REQUEST FOR INFORMATION DATE: September 19, 2016 NO.: RFI-287

Project Name: 15051-Webster University Interdisciplinary Science Building Project No.: 15051

Subject: Insulation at roof and overflow drains

ENLARGED DETAIL - ROOF DRAIN

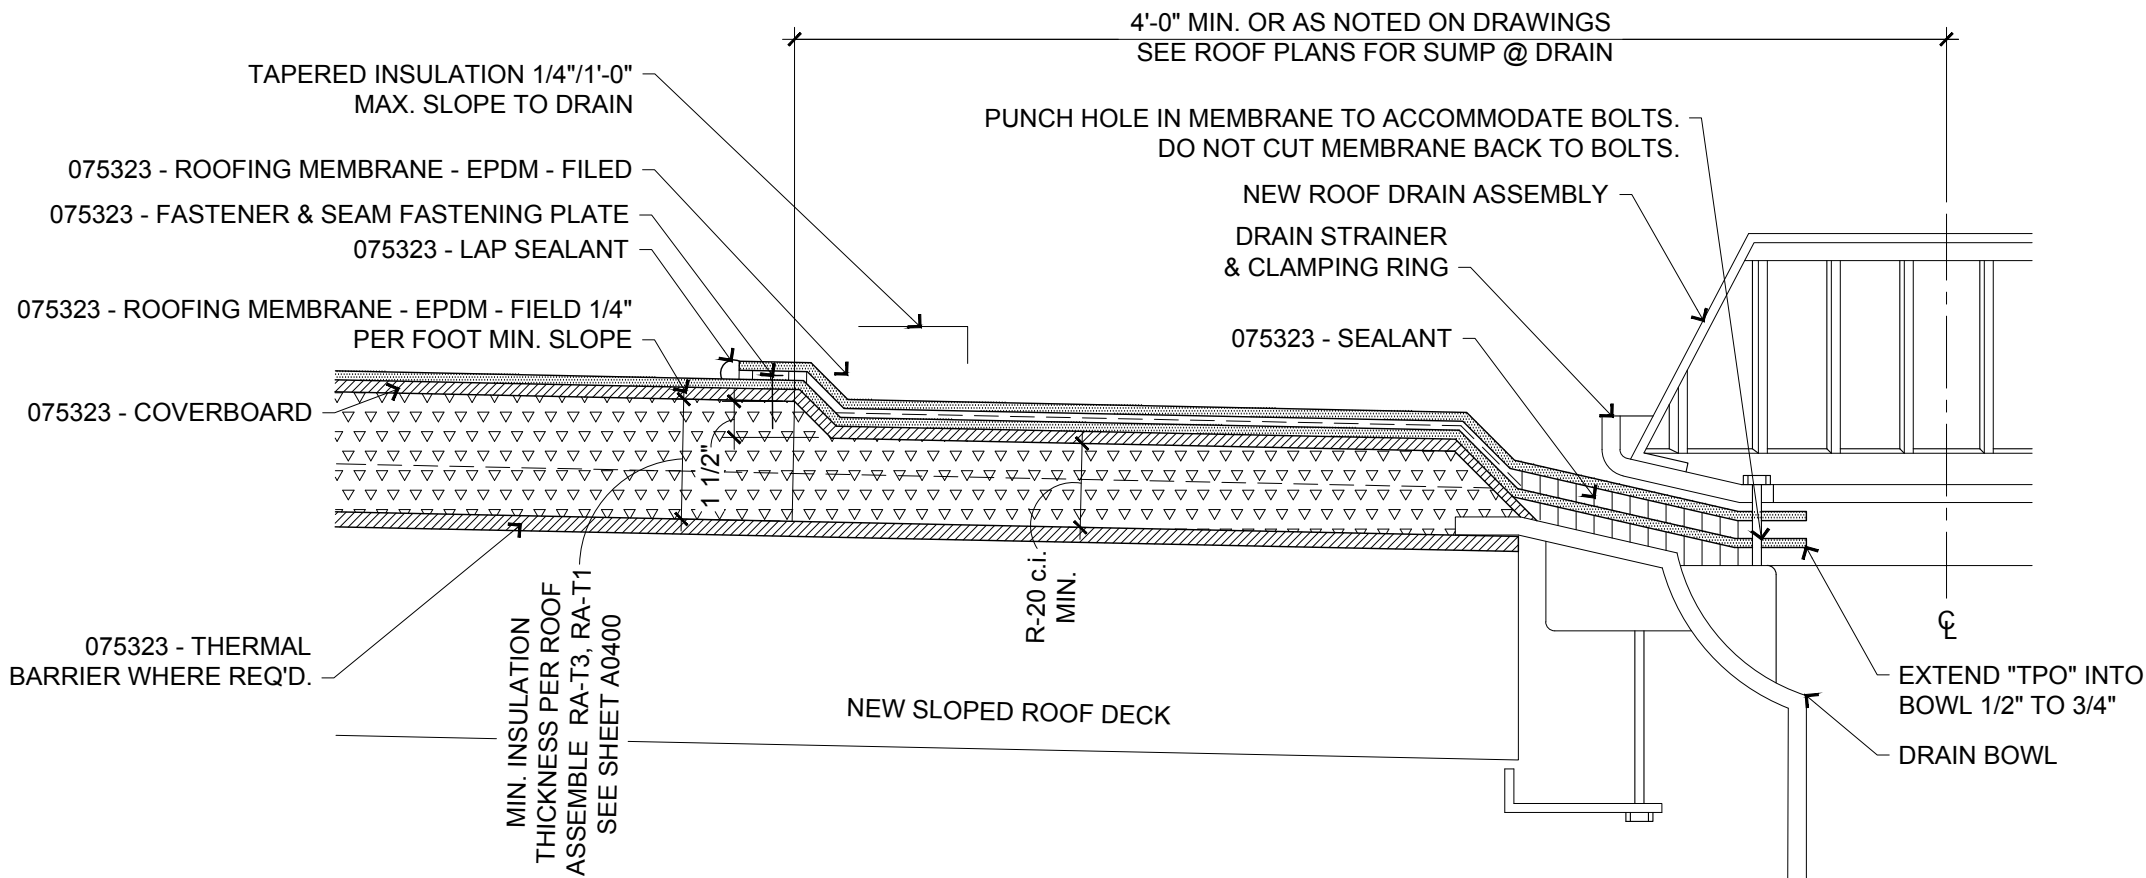
Please confirm we are to install the roof and overflow drains in the configuration as indicated on 1/P0502. This will cause a significant amount of insulation to be removed and we have experienced concerns from energy consultants on other projects preferring to raise the overflow drain to maximize the use of insulation.

Please see attached 1_A0471 - Roof Drain.pdf for revised layout. a min. of 3.5" of insulation should be maintained at the roof sumps.
